Access Compliance Report

Public Rights-of-Way

(Curb Ramps)

Intersection ID: 50566	Main Street: LEIGHANN_WOOD_LN	Cross Street: STEELE_CREEK_RD	Location: NW
ADA ID: 7B4F00961C0C	Ramp Type: Perp	Initial Pass/Fail: Fail	Overall Compliance: No
Severity Score: 25			
Codes/Mitigation Info/Possible Solution		Field Measurements/Component Compliance

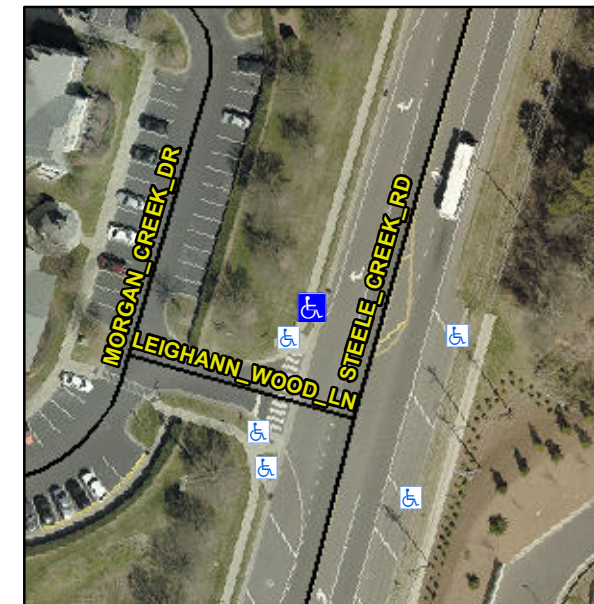
Not Found, R304.2.2

Compliance	Description	Data	Compliance	Description	Data
N/A	Ramp Length (in)	48.0	No	Ramp Slope (%)	13.9
Yes	Ramp Width (in)	48.0	Yes	Ramp XSlope (%)	0.4
N/A	Flare Type LT	N/A	N/A	Flare Type RT	N/A
N/A	Flare Slope LT (%)	N/A	N/A	Flare Slope RT (%)	N/A
N/A	Flare Traversable LT?	N/A	N/A	Flare Traversable RT?	N/A
N/A	Landing Length (in)	N/A	N/A	DWS Provided?	N/A
N/A	Landing Width (in)	N/A	N/A	DWS Contrast?	N/A
N/A	Landing Slope (%)	N/A	N/A	DWS Length (in)	N/A
N/A	Landing X Slope (%)	N/A	N/A	DWS Full Width?	N/A
N/A	Landing Curb? (Y/N)	N/A	N/A	DWS Offset (in)	N/A
N/A	Shared Landing?	N/A			
N/A	Gutter Ponding?	N/A	N/A	Gutter Slope (%)	N/A
N/A	Gutter Lip Ht (in)	N/A	N/A	Gutter X Slope (%)	N/A
N/A	Painted X Walk1?	No	N/A	Painted X Walk2?	N/A
	X Walk 1 Direction	To SE		X Walk 2 Direction	N/A
N/A	X Walk 1 Width (in)	N/A	N/A	X Walk 2 Width (in)	N/A
	X Walk 1 Slope (%)	2.8		X Walk 2 Slope (%)	N/A
	X Walk 1 X Slope (%)	0.8		X Walk 2 X Slope (%)	N/A

Remove & Replace Entire Ramp.
